**Transbay Transit
Center Building
50% CD Overview**

January 2011

SECOND LEVEL

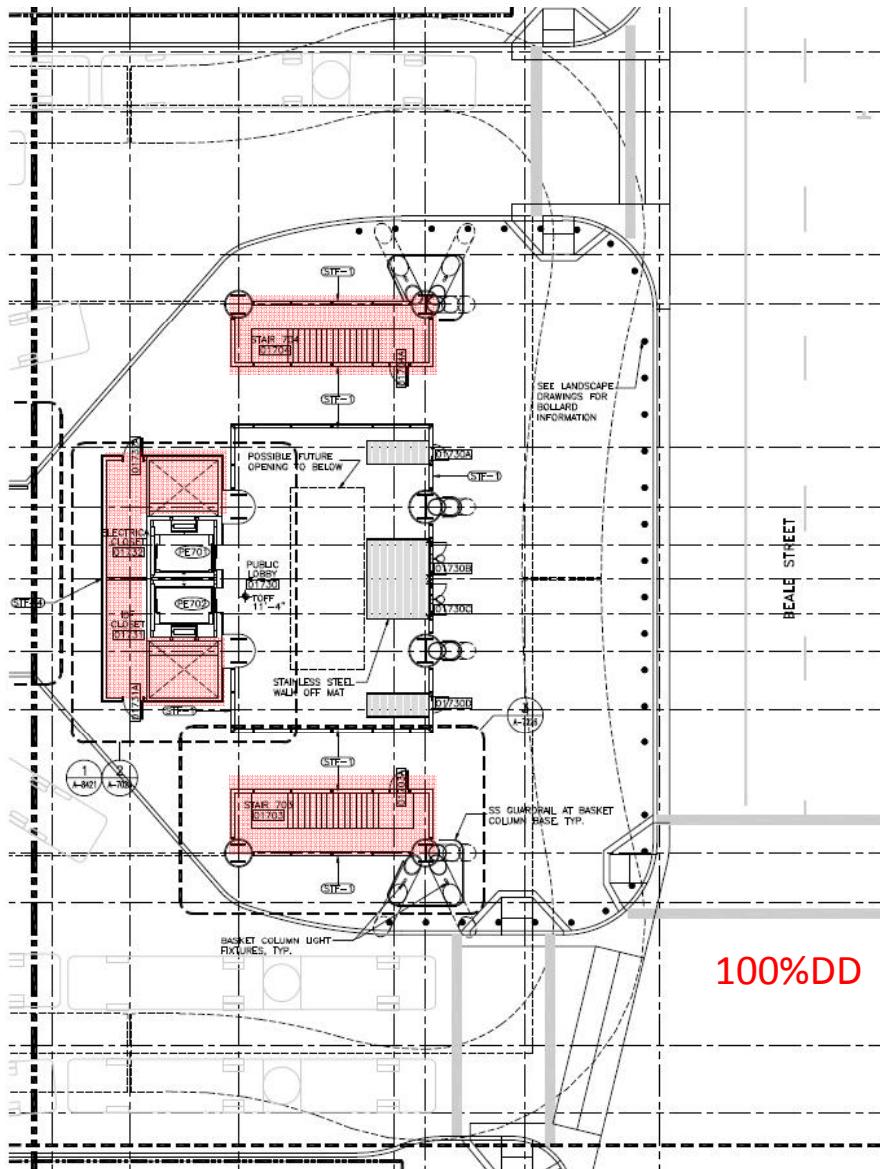
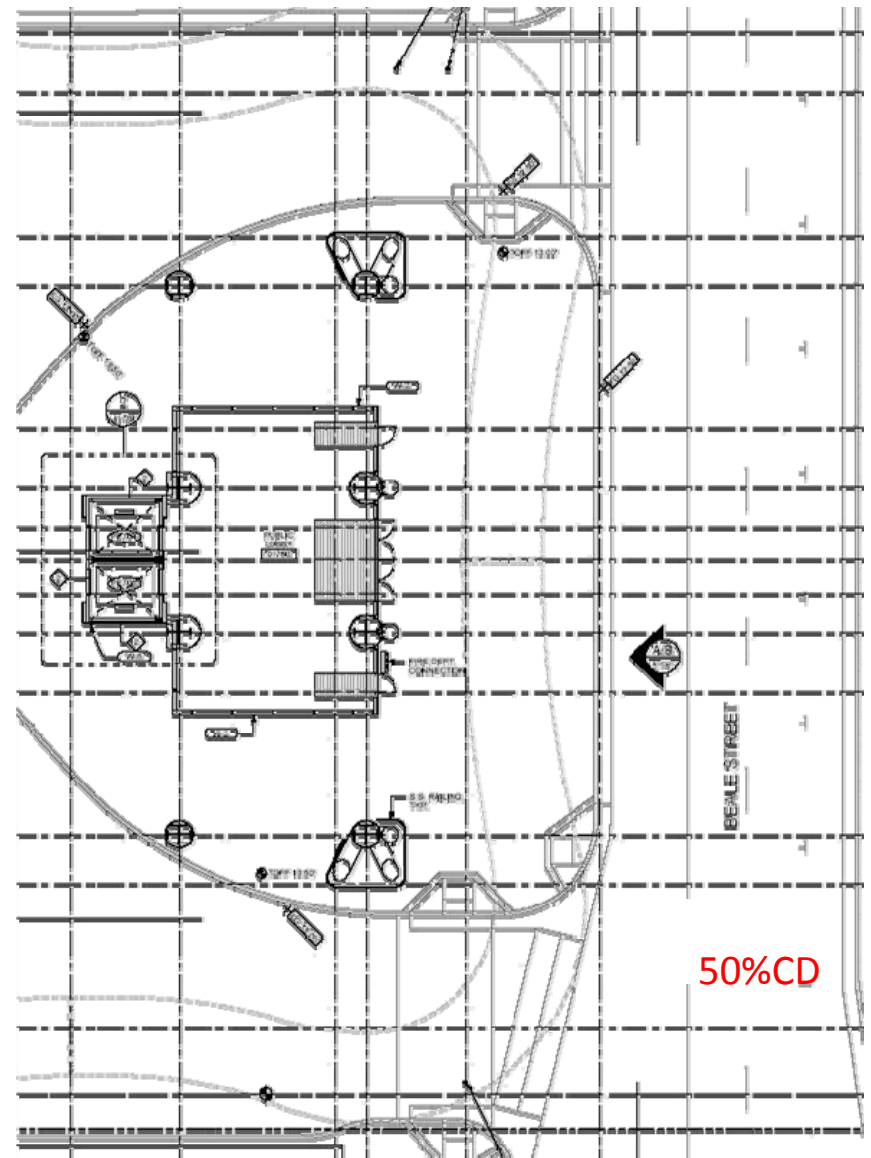
- Balcony deleted at 2nd Level
- Passenger Elevators flipped from front entry to rear entry (at 2nd Level)
- Elevator entry on both front & rear at Ground Level

LOWER CONCOURSE LEVEL

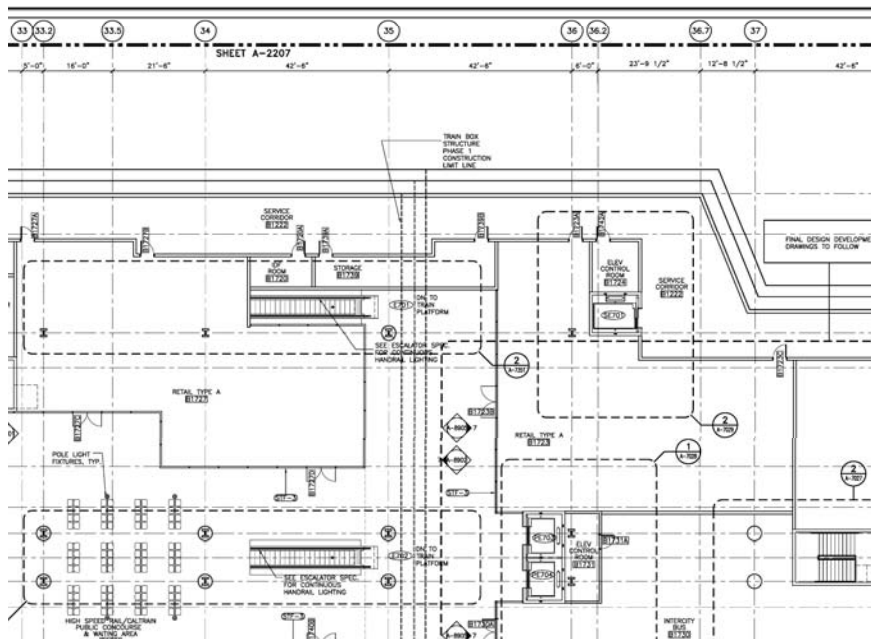
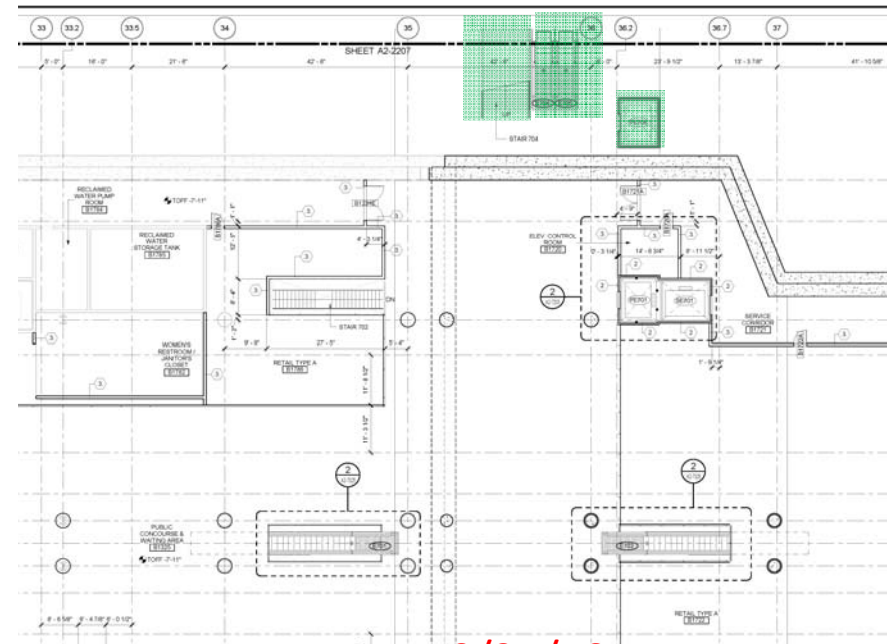
- Add Escalators connecting Lower Concourse to Ground Level
- Add Passenger Elevator connecting Lower Concourse to Ground Level
- Add Stair with Bike Channel connecting Lower Concourse to Ground Level

Loading Dock

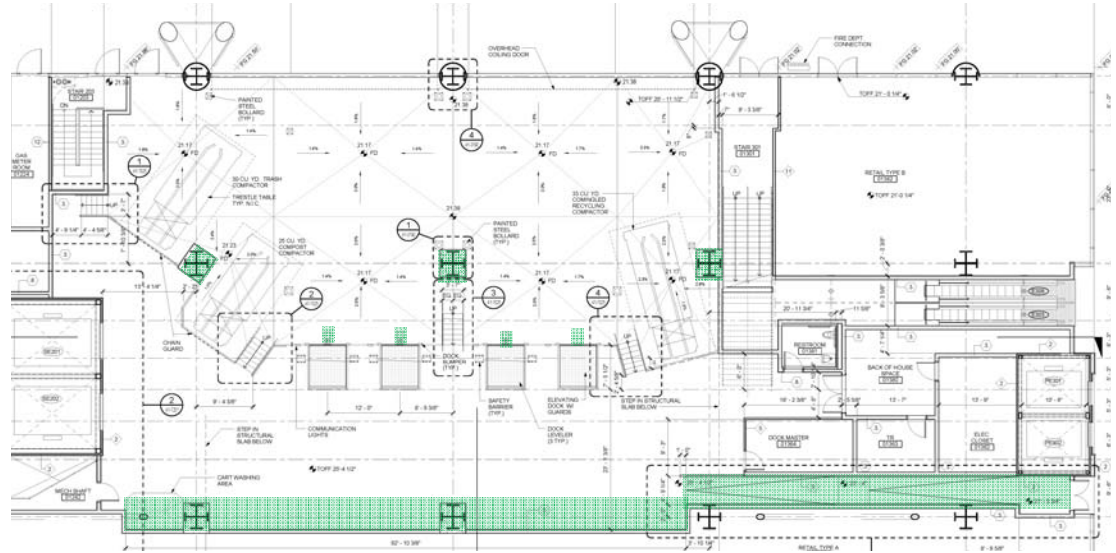
- Deleted refrigerated Trash Room
- Added truck restrain devices to the drawings only
- Added concrete encasement to steel columns
- Added Goods/ADA ramp
- Increased short tem storage area in the loading dock

Walk-off Mats

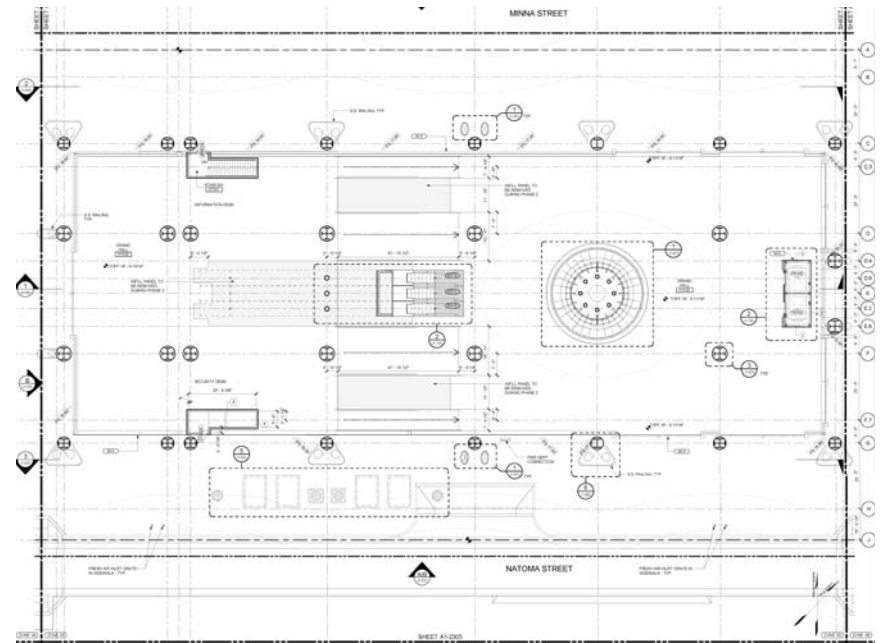
Deleted walk-off mats at Ground Level

Service Elevators SE201/202

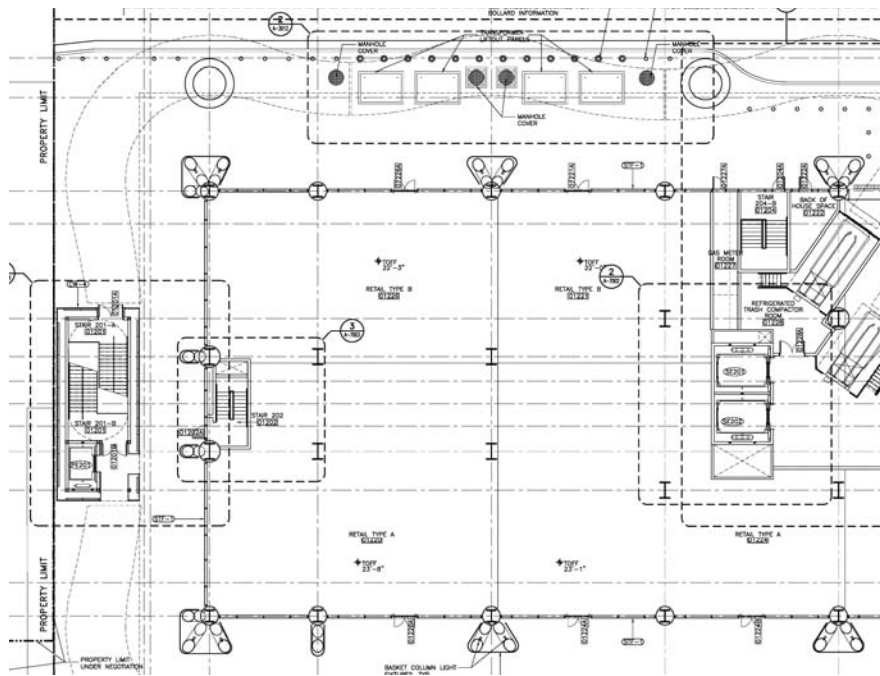
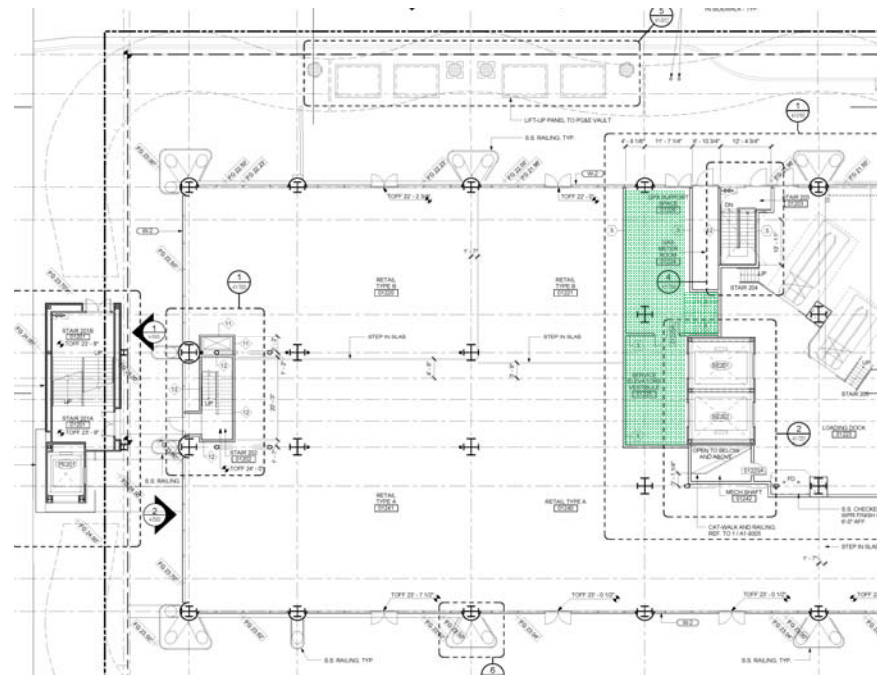
Added rear entry at Ground Level and Luggage Handling Room

Amtrak/Greyhound Interim Facilities

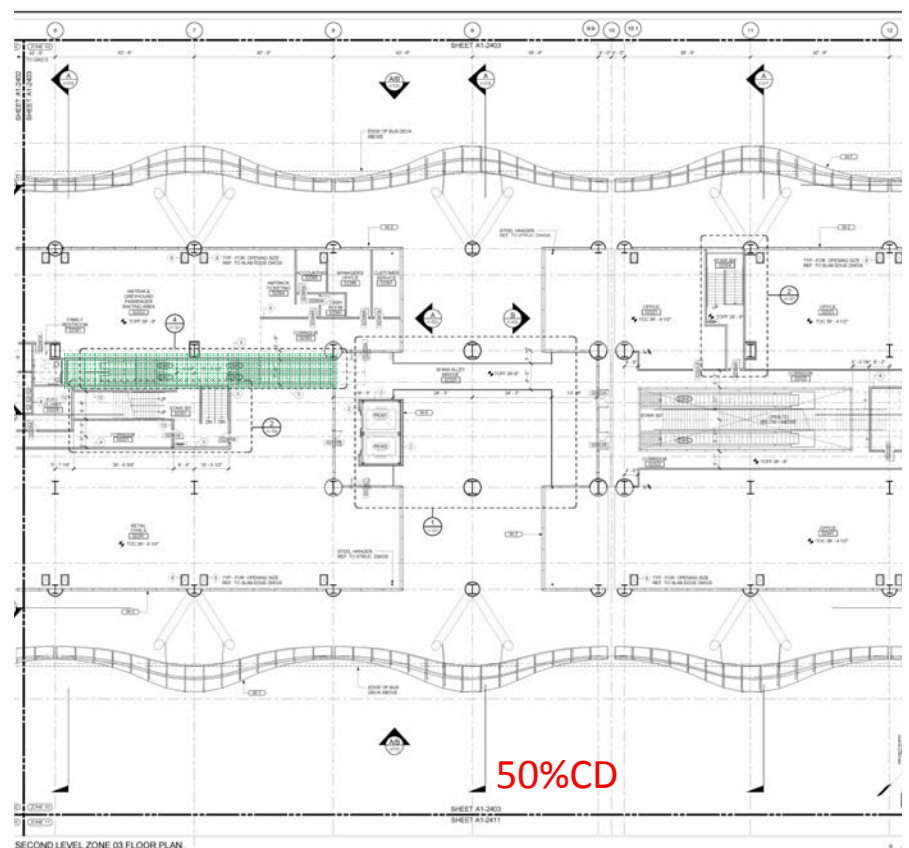
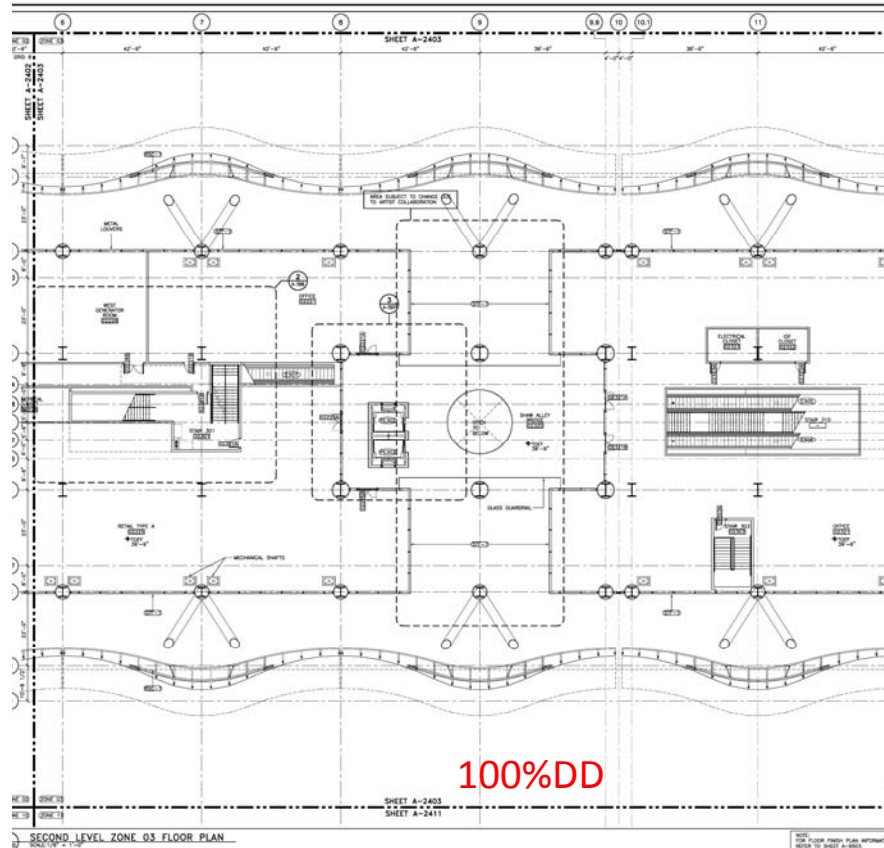
Add temporary Amtrak/Greyhound program at Second Floor

Shaw Alley Bridge

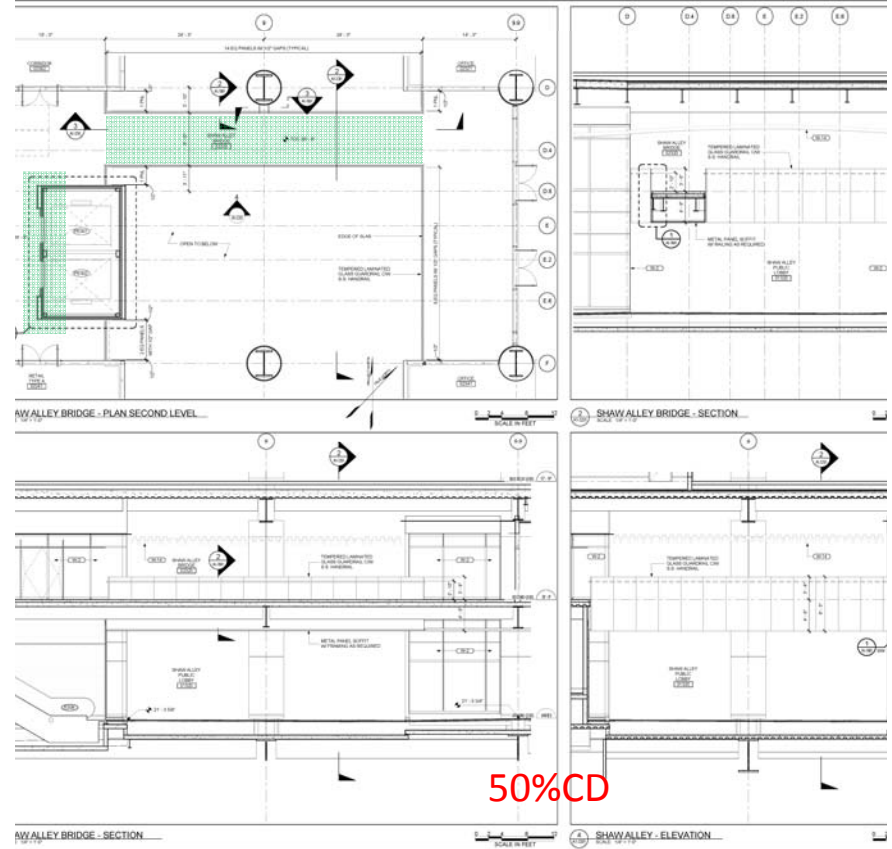
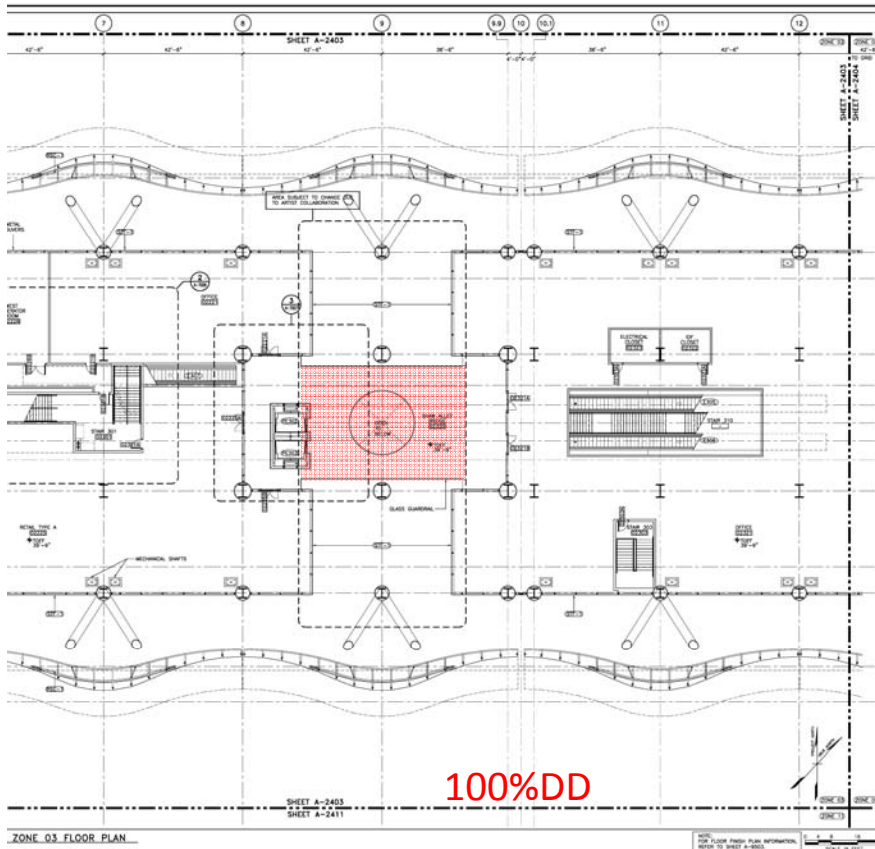
Reduced size of bridge & reversed elevator entry

Bus Deck Waterproofing

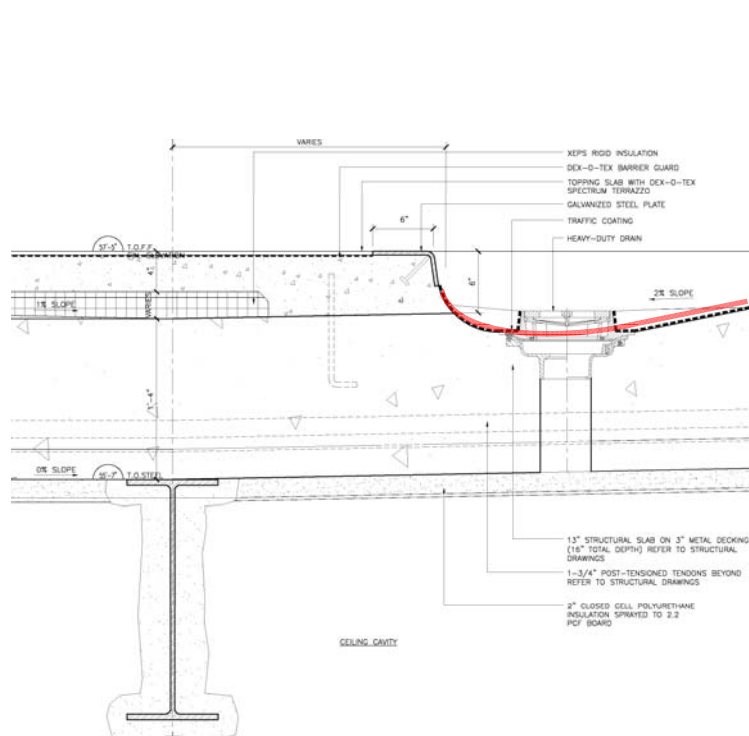
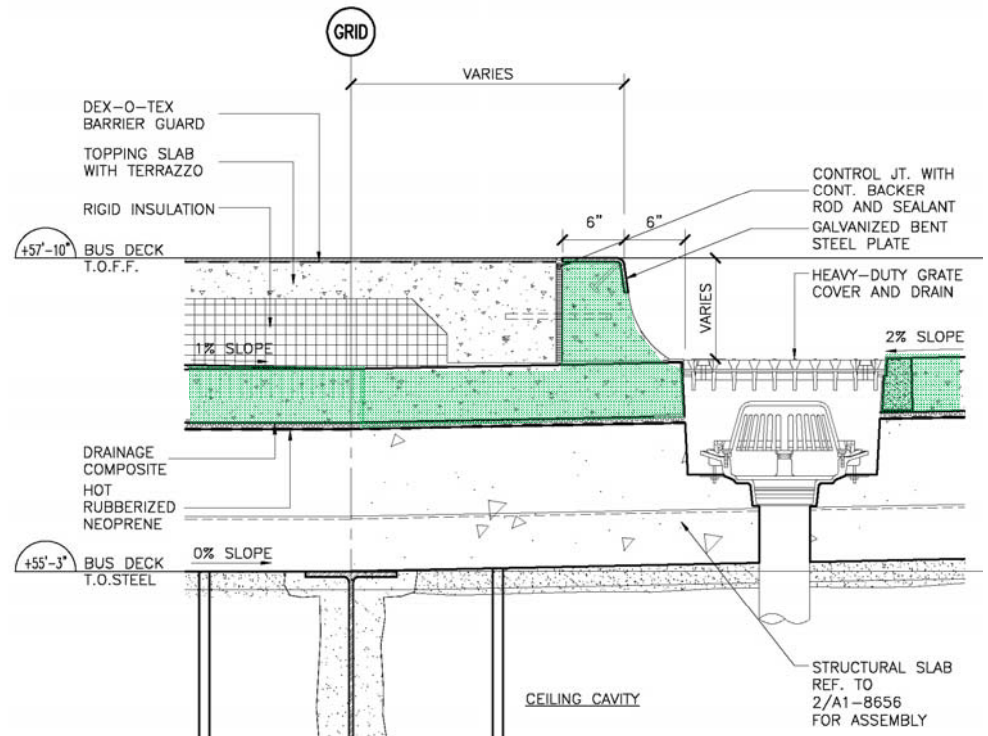
Change to protected WP membrane under 6" concrete topping
